### Safety Advisory Notice

SOMATOM Emotion 6 Slice Configuration

SOMATOM Emotion 16 Slice Configuration

**Re: SOMATOM Emotion 6 / 16 Slice Configuration with fatigued bolts holding the balance weights of the data measurement system (DMS)**

Fig. 1: Bolts used to fix the DMS balance weight

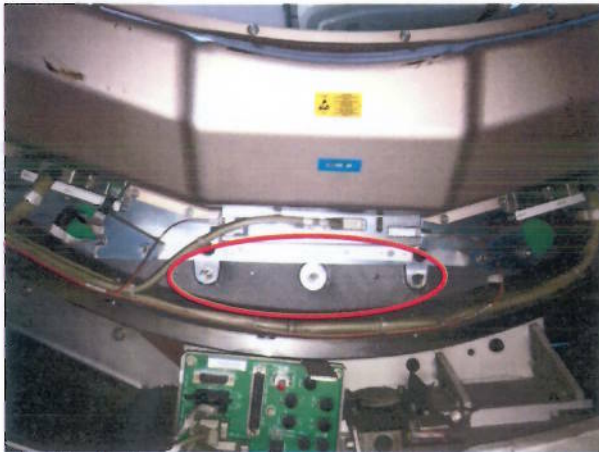
We recently detected that the bolts (Fig. 1) used to fix the balance weight of the DMS may show signs of metal fatigue. Accordingly the function of these bolts may potentially degrade over time and impact stability.

The rupture of a single bolt is not posing a hazard by itself but it cannot be fully ruled out that all the bolts break over time causing the DMS balance weight to drop into the gantry. As a consequence ongoing scans will be aborted immediately. Under unfavorable circumstances mechanical damage of the gantry cover and of the Plexiglas protection ring inside the gantry opening may occur. This situation potentially exposes the patient or operator to the risk of getting into contact with rotating parts.

We have carefully analyzed this issue and developed a solution improving the mechanical stability of the assembly. As instructed by the Update Information UI CT008/15/P our service engineers will start in Mai - 2015 to replace all the bolts holding the DMS balance weight by a new model. The aging properties of the new bolts are far superior and material fatigue resistance is drastically increased.
